Project: IEEE P802.15 Working Group for Wireless Personal Area Networks (WPANs)

Submission Title: TG4k FSK Proposal Enhancements

Re: Recommendations to TG4k

SFD Length

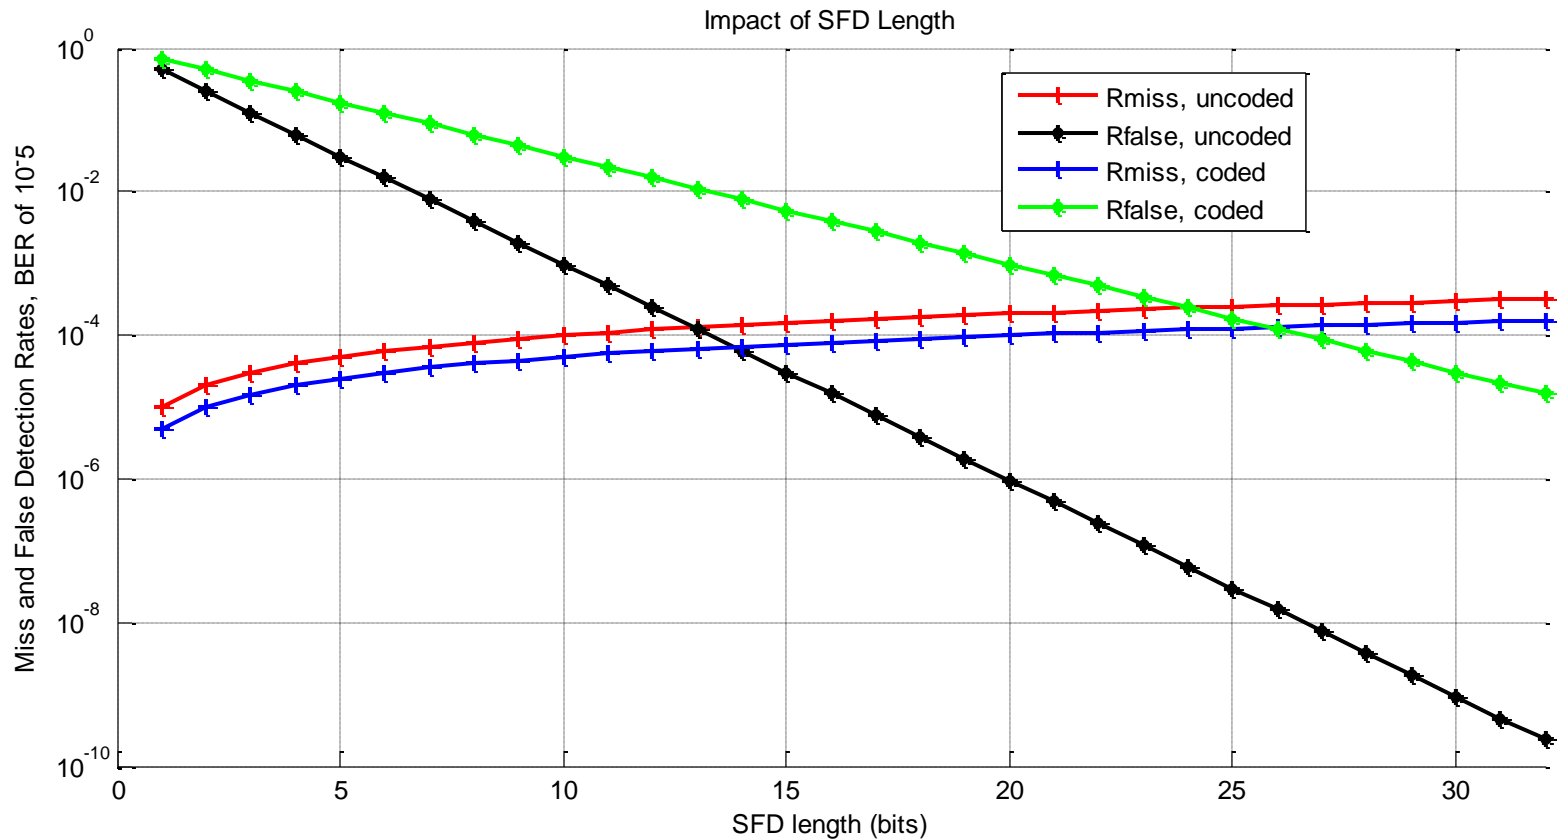
- Cross-over points at 10^{-4} with $n=13$ for un-coded and $n=26$ for coded packets
- ***Recommend an SFD length of 3 bytes if FEC is included, otherwise 2 bytes.***

Channel Spacing

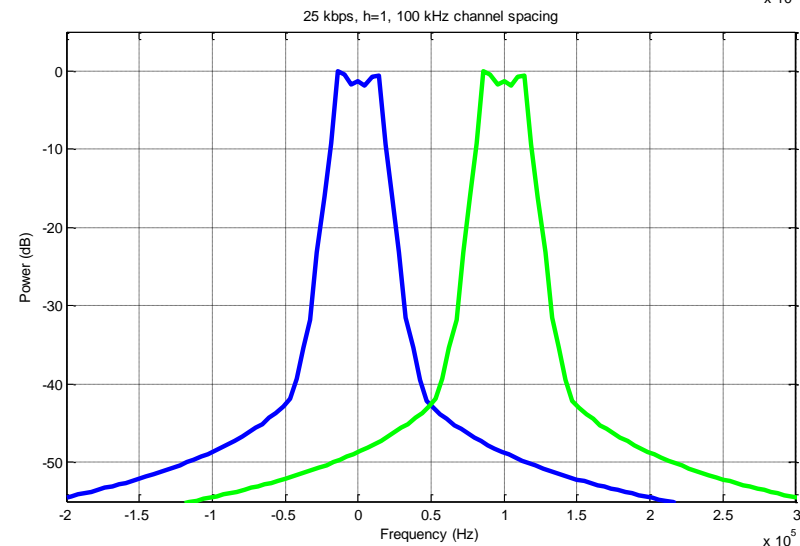
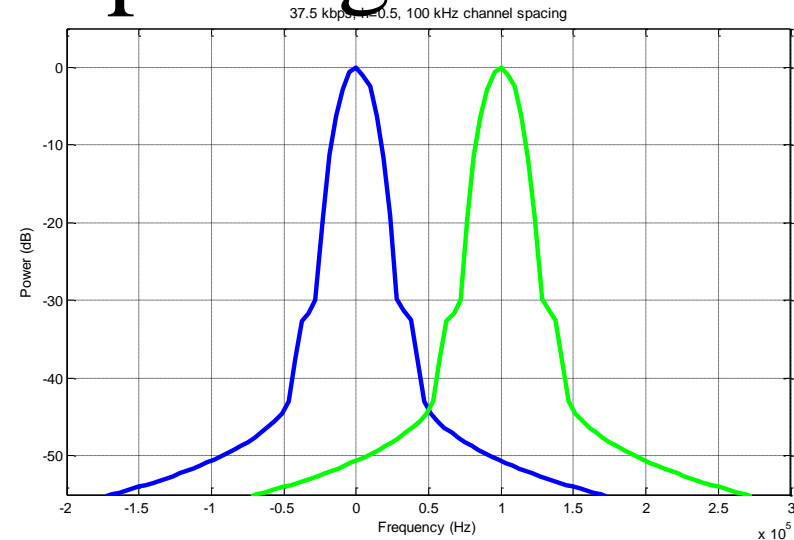
- Two channel spacings currently defined
 - 100 kHz in Europe
 - 200 kHz elsewhere
 - **Recommend using 100 kHz everywhere***
 - Spectral properties are suitable
 - Doubles the number of available channels
- * Except perhaps at 2.4 GHz (see later slide)
